Re: Request for Increase in Maximum Surface Tubing Pressure
Order SWD-1310
Delaware Ranch SWD #1
Mewbourne Oil Company

Mewbourne Oil Company
Delaware Ranch SWD #1
660 FSL & 660 FEL Section 11-26S-28E
3001522734

From: Jones, William V., EMNRD
Sent: Friday, February 03, 2012 3:43 PM
To: 'Drew Robison'
Cc: Brooks, David K., EMNRD; Dade, Randy, EMNRD
Subject: RE: Request for Increase in Max Surface Injection Pressure (SWD-1310)

Current Schematic

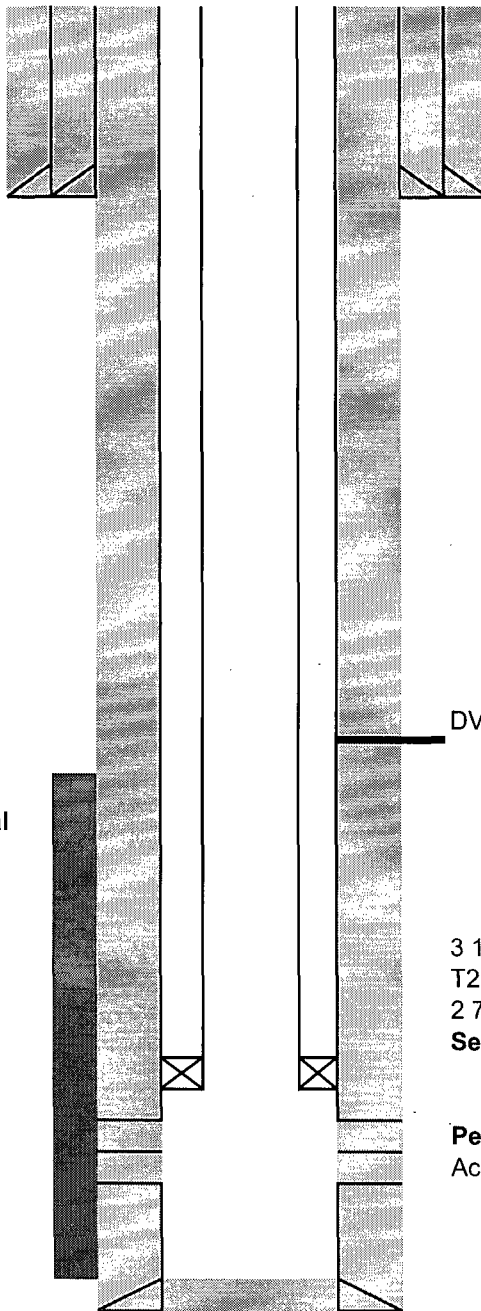
Hello Drew,
Would you also send a quick, simple wellbore sketch showing the casing, packer setting depth, and current perforations?

Hello Drew,
I am drafting today the amended permit with the actual upper perf and the adjusted pressure limit.
You will have two permits on this same well.
They both expire two years from the date of issue (as per the specific language in the permits). If you decide before the first permit expires to add additional perforations uphole, then you can do that without repeating the notices to affected parties.
